Re:FCC ID QLA500MHZ  
Applicant: Mala GeoScience AB (publ)  
Correspondence Reference Number: 24229  
731 Confirmation Number: EA369105

Figure 1. Pulse characteristic of a 500 MHz UWB-unit.

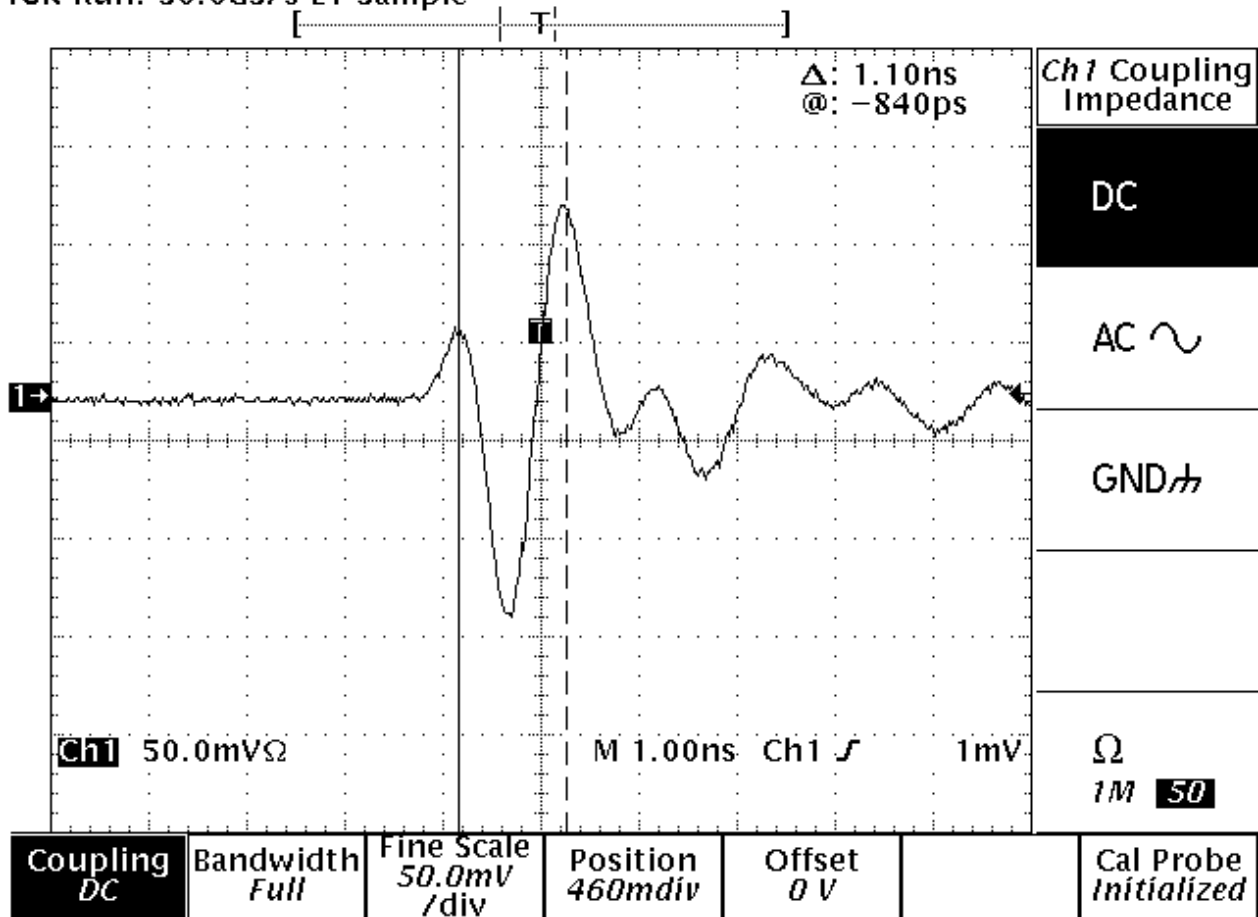
9) What is the pulse width of this device. Is the pulse random (dithered) or periodic? Upload an exhibit with the pulse characteristics of this device. Include a plot.

The 500 MHz UWB-unit has a pulse width of about 1 ns, in air. A plot of the pulse is shown in figure 1 below. The pulse is periodic with a repetition frequency of 100 kHz.
